CONSTRUCTION SUMMARY

Forestside Estates Inc.

LOT NUMBER	PHASE	HOUSE TYPE	CLOSING DATE	
338 BLOCK 4	6-III	Red Pine 2D-b	27-Apr-23

BUILDING B SUITE 338 BLK 4

KITCHEN PLAN 2Db

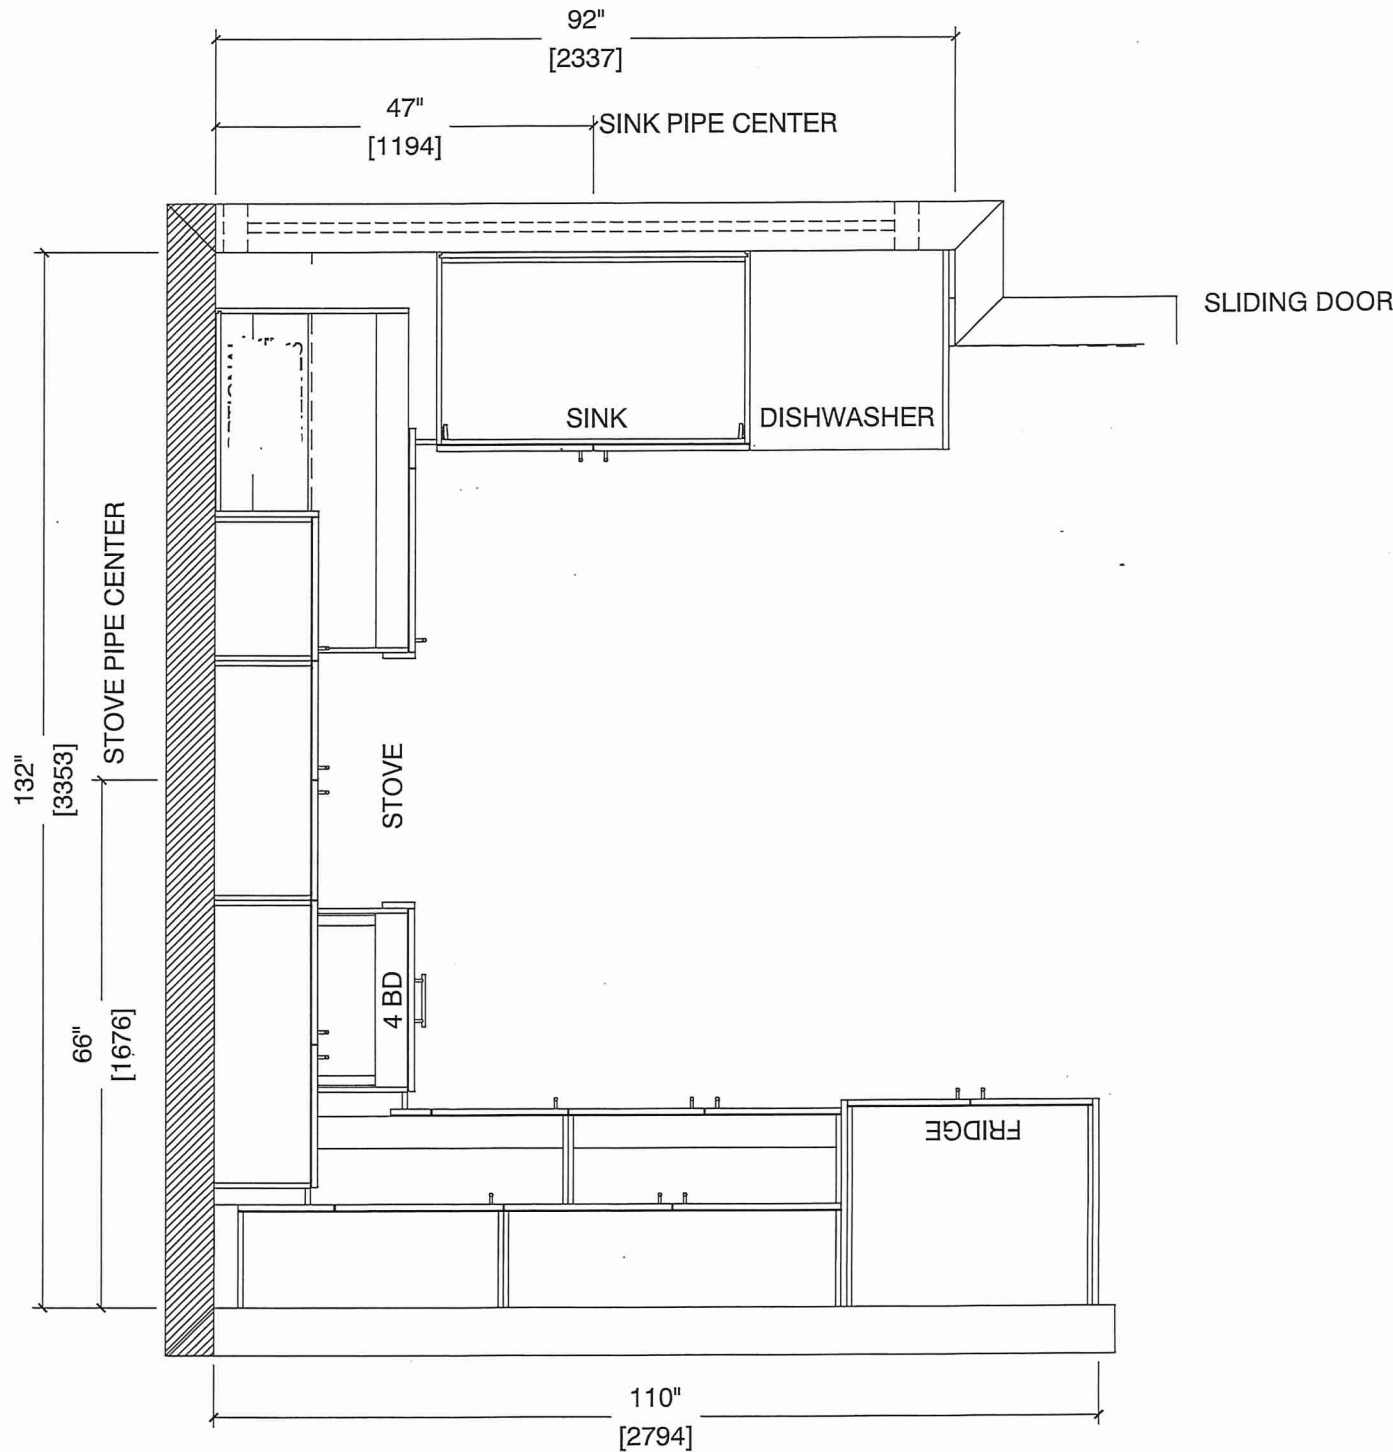
1 - KITCHEN- PLUMBING - Install the UPGRADED UNDERMOUNT sink in the kitchen- Install the BLANCO QUATRUS R15 U2- Model # 401519
Note:

1 - KITCHEN - COUNTER - Install UPGRADED "L" EDGE throughout the kitchen where applicable. (see sketch)
Note:

130 - KITCHEN - TILE - Install UPGRADED 2 FLOOR TILE (20X20 Pulpis Gris) throughout the kitchen in lieu of the builder's standard lamiante. To be Installed in the kitchen only. To be installed straight/stacked. (See sketch)
Note: Approved as per Vince
